WSJ1 - Replacing Lid for Closing Aid Motor (Workshop Campaign)

Model Line: **Macan (XAB)**

Model Year: **As of 2024 up to 2026**

Concerns: **Lid for closing aid motor**

Installation position of lid for closing aid motor

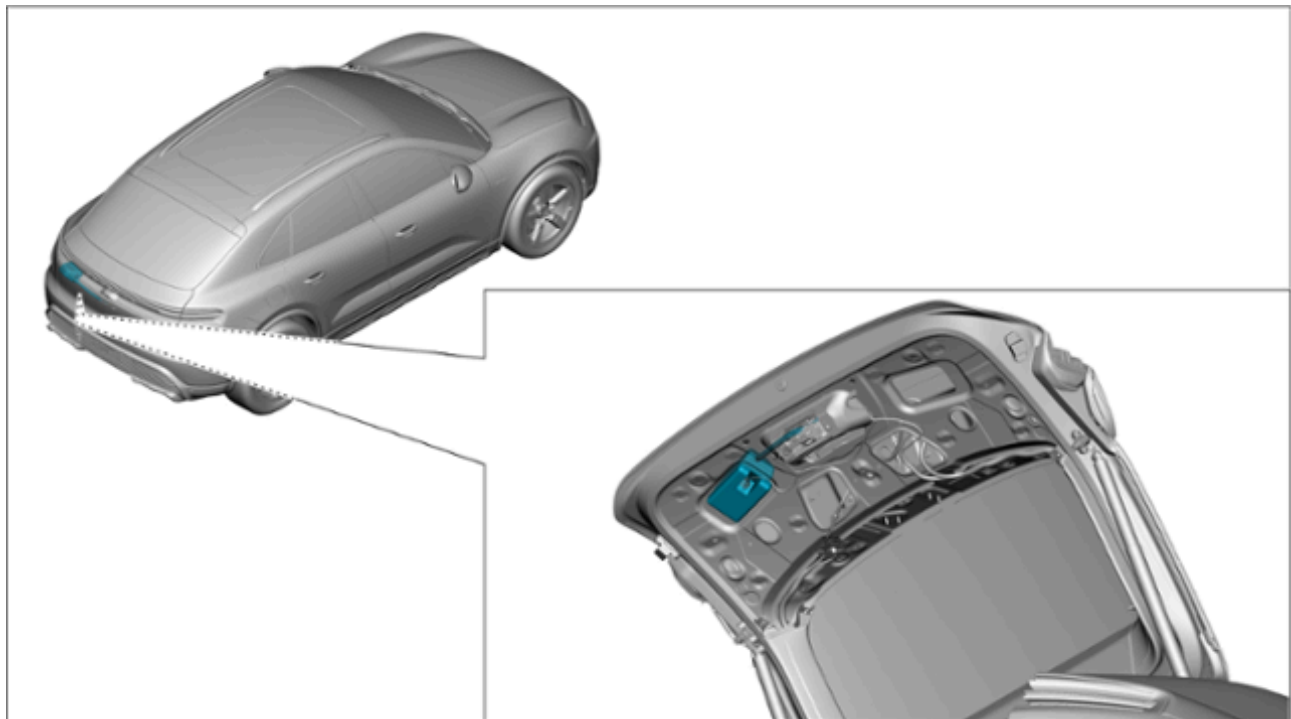
Cause: **Electric closing aids for the rear lid were installed on the affected vehicles, on which the microswitch for determining the lid position was not installed correctly.**

Due to the faulty signal from the microswitch, the rear lid cannot be opened, closed or locked and the message "Doors open" is displayed on the instrument cluster.

Campaign: Replace lid for closing aid motor with an optimized type.

- Work Procedure: 1 Replace lid for closing aid motor.
For procedure, see: ⇒ *Workshop Manual '557419 Removing and installing lid for closing aid motor'*
- 2 Enter the campaign in the Warranty and Maintenance Logbook.
